INITIAL FIRE SAFETY INSPECTION REPORT

Northern Fashion (Extension)

RSC ID: 24770

Date: 27-Nov-2023

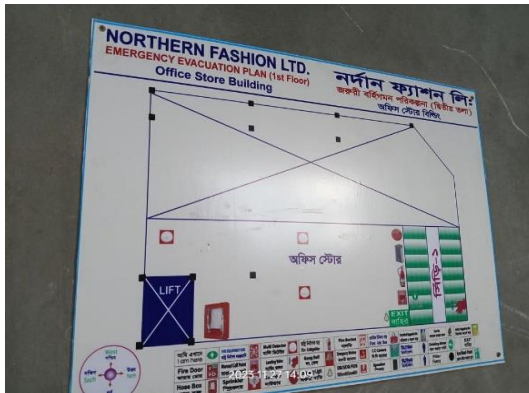
Sl No.	Category	Findings	Required Action	Remediation Time Frame
F-1	Fire Rated Construction	The exit stairs are not separated from work areas, other spaces on each floor by fire-rated construction. Location: B# F (Office Store)	Provide minimum 2-hr fire rated construction for buildings 4 storied or more and 1-hr for up to 3 storied. Seal all unprotected openings to separate the exit stairs from work areas and other spaces on all floor levels by 90 minutes for 2 hr. construction and 60 minutes for 1-hr construction. Ensure that the fire rated doors are self-closing and positive latching and that they are provided with fire exit (panic) hardware where serving production floors. If fire rated doors are required to be held open for functional reasons, provide automatic closing devices tied to the fire alarm system.	Within 3 months
